#### SAFETY RECALL CODE 0830 - SIDESTAND PIVOT BOLT FOR 2005 FIREBOLT XB12R AND LIGHTNING XB12S, XB9SX

B-060

Buell Motorcycle Company has decided that there is a potential safety defect with the sidestand bracket assemblies on certain 2005 XB12R, XB12S, XB9SX model motorcycles.

Figure 2. Sidestand Assembly

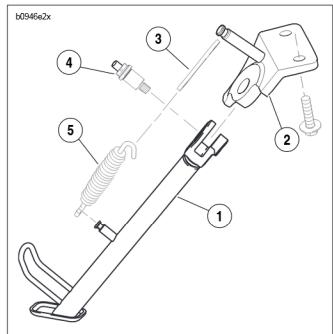
- Vehicle should be placed onto the lift with front or rear tire placed in the wheel vise in order to successfully perform this procedure.
- Sidestand assembly does not have to be removed from motorcycle in order to remove sidestand pivot bolt.
- Remove two fasteners from left side of chin fairing.
- See Figure 2. Remove sidestand pivot bolt (4).
  - a. Retract sidestand leg.
  - Remove sidestand spring (5) and spring extension plate (3) using SNAP-ON SPRING TOOL (Part No. HE-52B).
  - c. Remove sidestand pivot bolt (4).

- See Figure 2. Install sidestand pivot bolt (4) tightening to 18-20 ft-lbs (24-27 Nm).
- Retract sidestand leg.
- e. Install spring extension plate (3) and sidestand spring (5) using SNAP-ON SPRING TOOL (Part No. HE-52B).
- Apply LOCTITE 272 (Red) and install the two left side chin fairing fasteners and tighten to 36-48 in. lbs (Nm).
